REVO, INC.
SERVICE BULLETIN B-78

SUBJECT: Horizontal Tail Attachment Fittings

Airplanes Affected: All Colonial C-2, Lake LA-4 & LA-4-200 Models

VIEW IS OF LEFT SIDE, LOOKING FORWARD

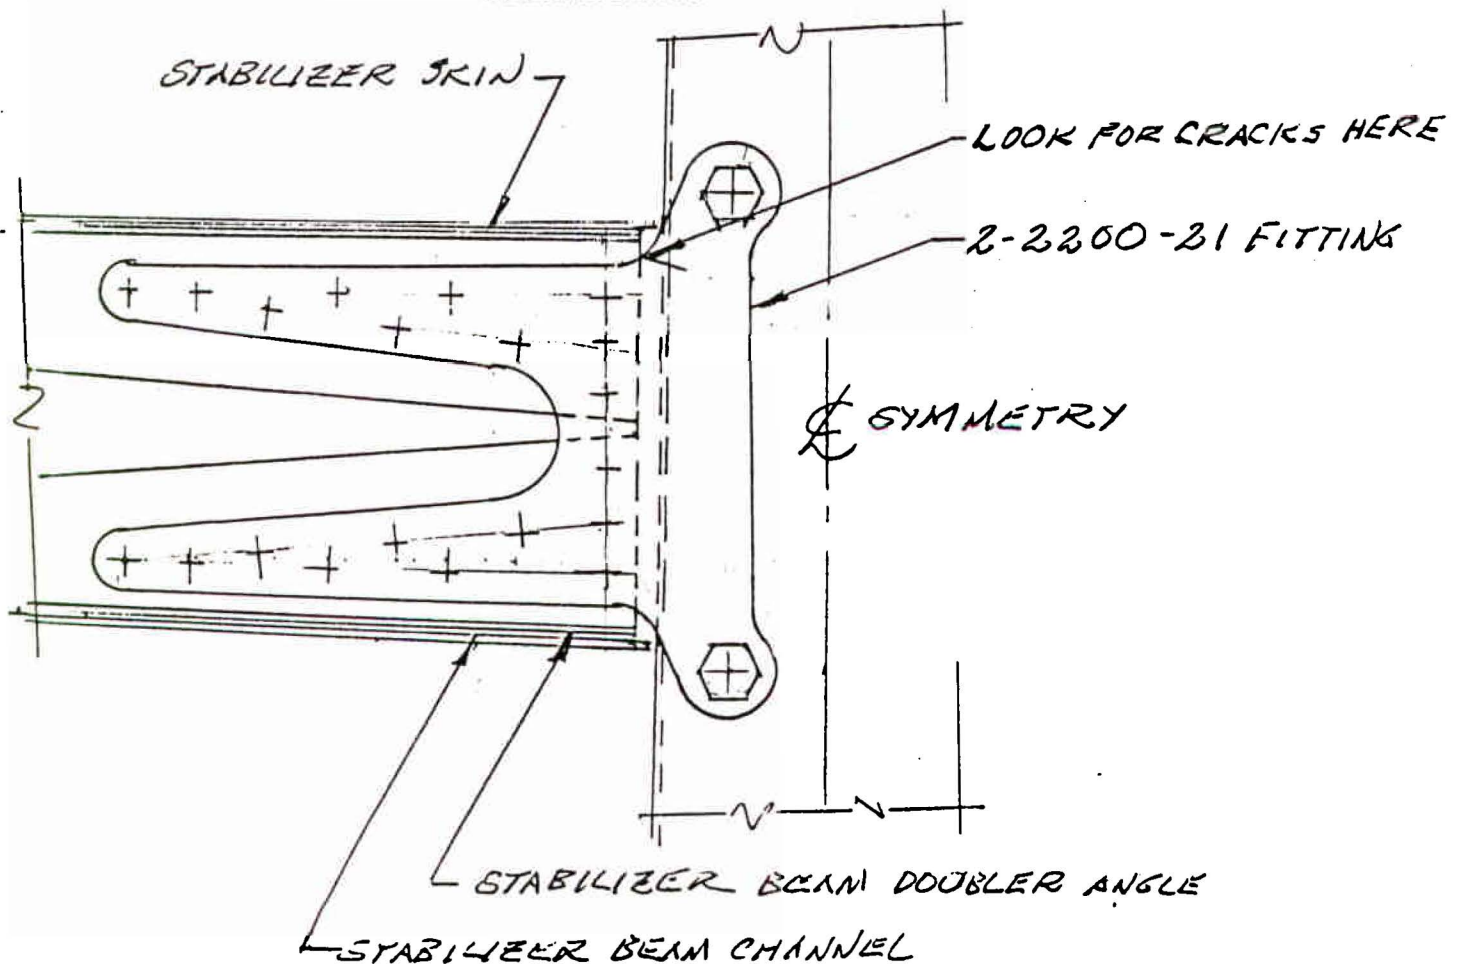
Description: A recent incident involving failure of the attachment fitting of the left-hand horizontal stabilizer to the vertical fin has shown that a cause for initiation of a crack in the fitting can exist. The area in questions is shown below.

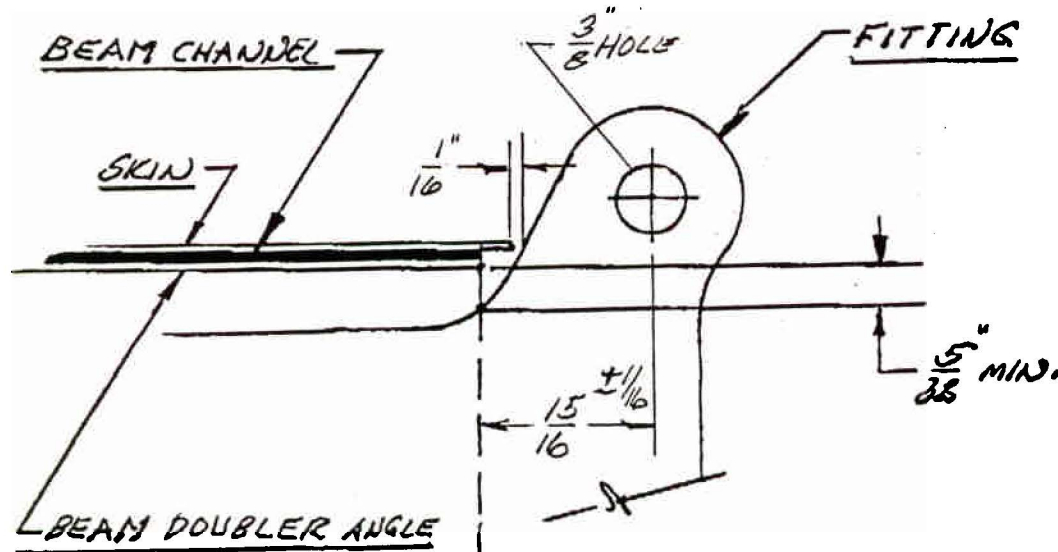
The fitting in the area of its attachment to the horizontal stabilizer rear beam may be initially inspected by raising the elevator and determining the distance between the fitting and the flanges of the beam doubler angle, and any contact of the fitting with the skin. (See below). Both left and right stabilizer halves, top and bottom, must be checked.

The shank of a 5/32 drill bit may be used to check the gap.

1. If the gap is at least 5/32", and the stabilizer skin is not contacting the fitting, no further action is necessary.
2. If the gap is at least 5/32", but the skin has less than 1/16" clearance, simply trim off the skin edge to provide at least 1/16" clearance.
3. If the gap is less than 5/32", at any fitting, it will be necessary to remove the fitting in order to properly inspect it. This entails removal of the horizontal tail half from the airplane. (A guide to this procedure is in the appendix to this Bulletin.)
